APPLICATION FOR PERMIT TO DRILL		5. MINERAL LEASE NO: ML-47970	6. SURFACE: State
1A. TYPE OF WORK: DRILL <input checked="" type="checkbox"/> REENTER <input type="checkbox"/> DEEPEN <input type="checkbox"/>		7. IF INDIAN, ALLOTTEE OR TRIBE NAME:

2. NAME OF OPERATOR: The Houston Exploration Company		9. WELL NAME and NUMBER: North Walker Hollow 15-36-6-23	
3. ADDRESS OF OPERATOR: 1100 Louisiana Suite 20 CITY Houston STATE TX ZIP 77002		PHONE NUMBER: (713) 830-6800	10. FIELD AND POOL, OR WILDCAT: Undesignated

**DIVISION OF OIL, GAS AND MINING
APPLICATION FOR PERMIT TO DRILL
STATEMENT OF BASIS**

Well name:	2007-04 Houston N. Walker Hollow 15-36-6-23	
Operator:	The Houston Exploration Co.	
String type:	Surface	Project ID: 43-047-39094
Location:	Uintah County, Utah

Casing Schematic

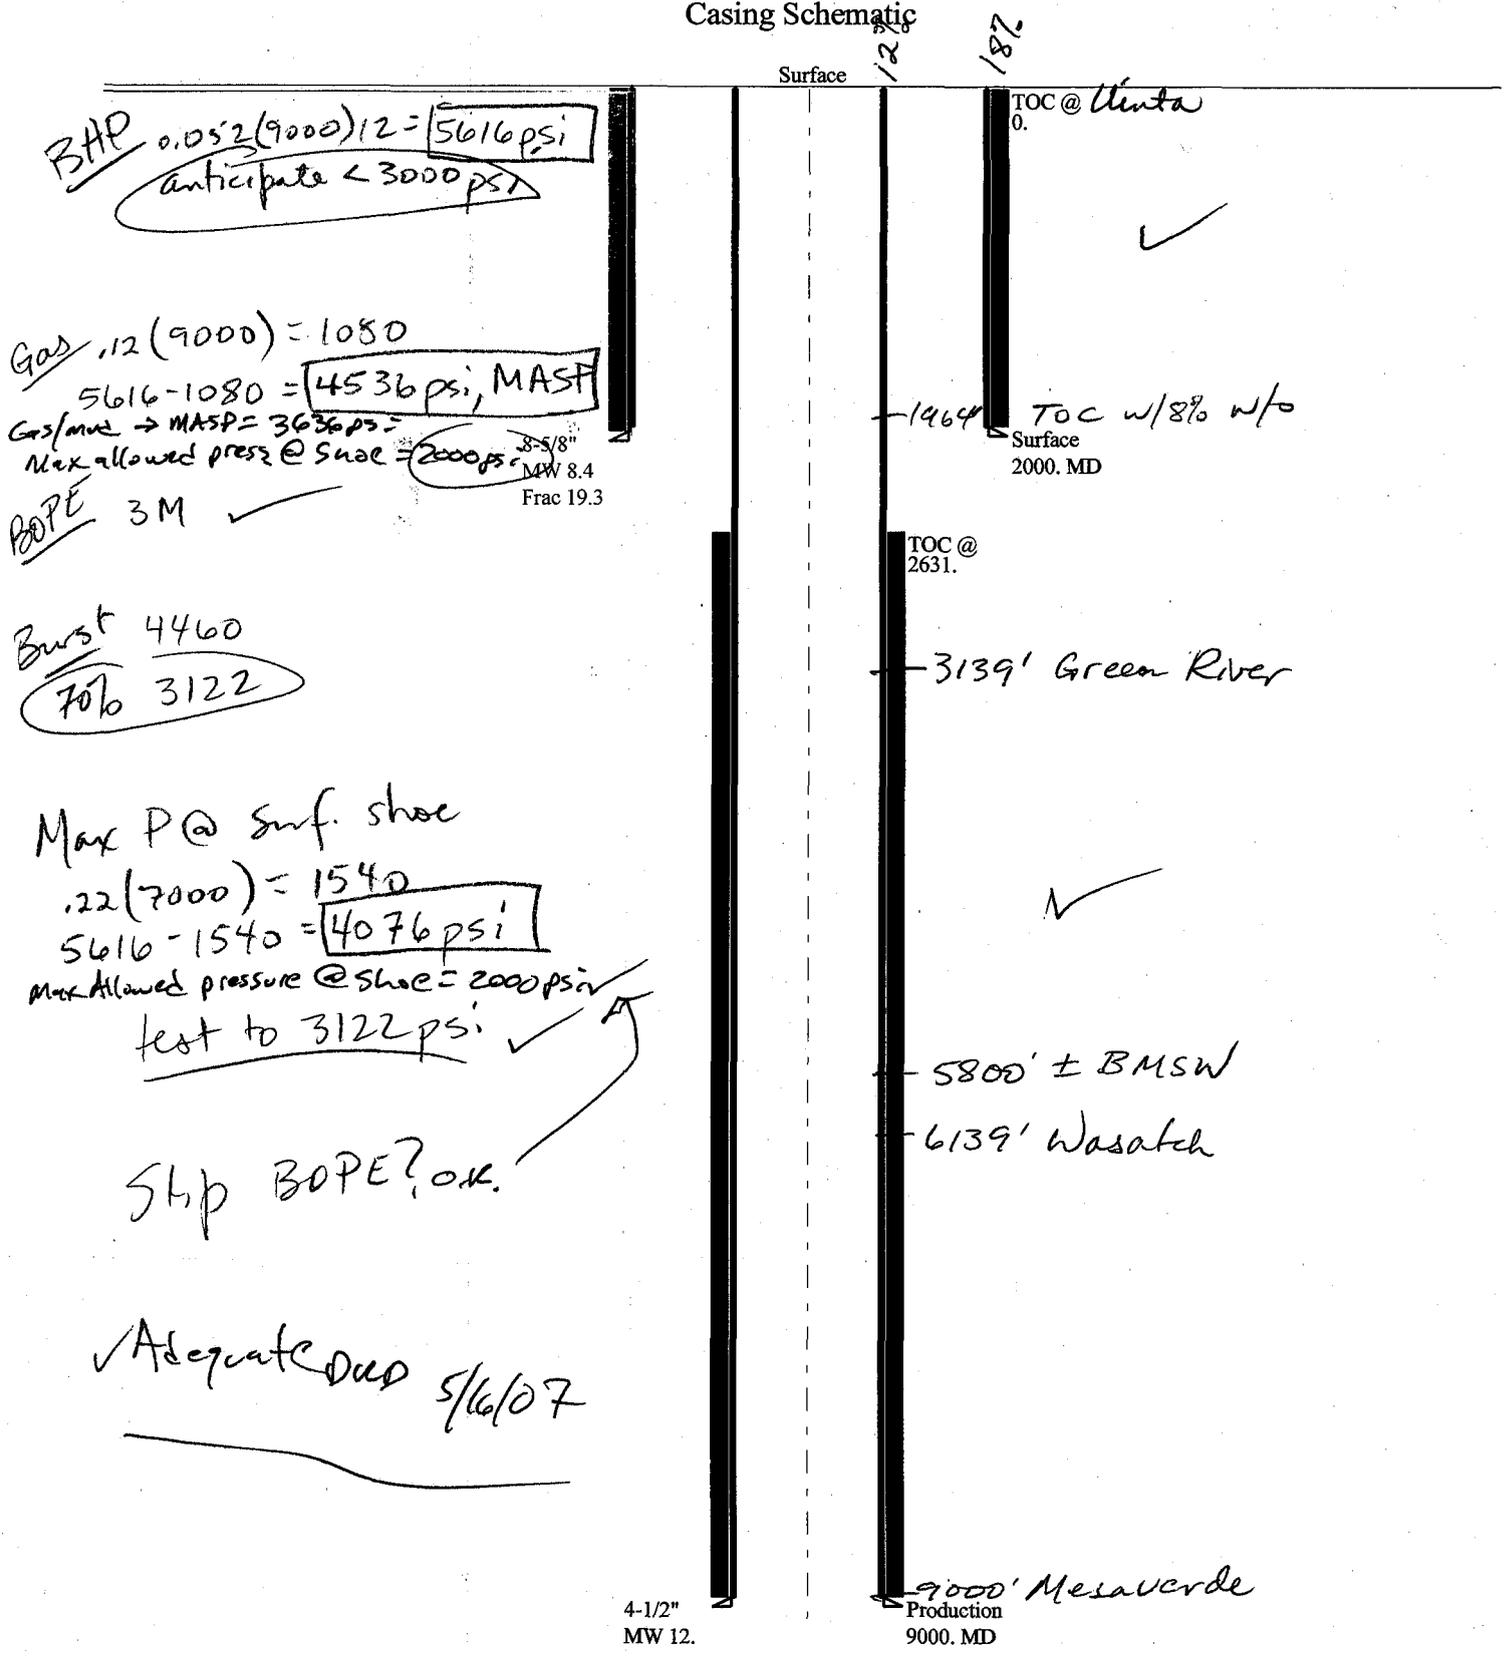
BHP $0.052(9000)12 = 5616 \text{ psi}$
 anticipate < 3000 psi

Gas $.12(9000) = 1080$
 $5616 - 1080 = 4536 \text{ psi, MASP}$
 Gas/mud \rightarrow MASP = 3636 psi
 Max allowed press @ shoe = 2000 psi
 8-5/8" MW 8.4
 Frac 19.3

BOPE 3M ✓

Burst 4460
 70% 3122

Max P @ Surf. shoe
 $.22(7000) = 1540$
 $5616 - 1540 = 4076 \text{ psi}$
 Max Allowed pressure @ shoe = 2000 psi
 test to 3122 psi ✓

Slip BOPE? OK.

✓ Adequate DUD 5/6/07
